Husqvarna

SB, 261, Muffler, 1998-06

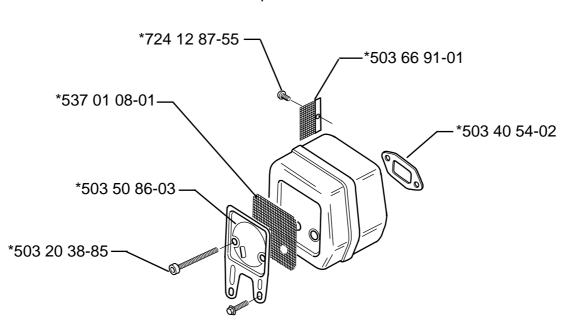
A modified muffler has been introduced for this model since spare parts list 106 25 01-61 was printed. The muffler has a dual outlets and is unique to model 261. The following part numbers apply:

Note! This muffler has a dual exhaust outlet and has therefore also two screens.

Muffler assy.	503 97 25-02	
Bolt	724 12 87-55	
Spark arrestor mesh	503 66 91-01	side
Spark arrestor mesh	537 01 08-01	front
Muffler support	503 50 86-03

CAUTION! The screens must be replaced, if damaged. The saw will be overheated, if the screens are clogged. This results in damage on the cylinder and the piston. Never use a saw with a clogged or defective muffler.
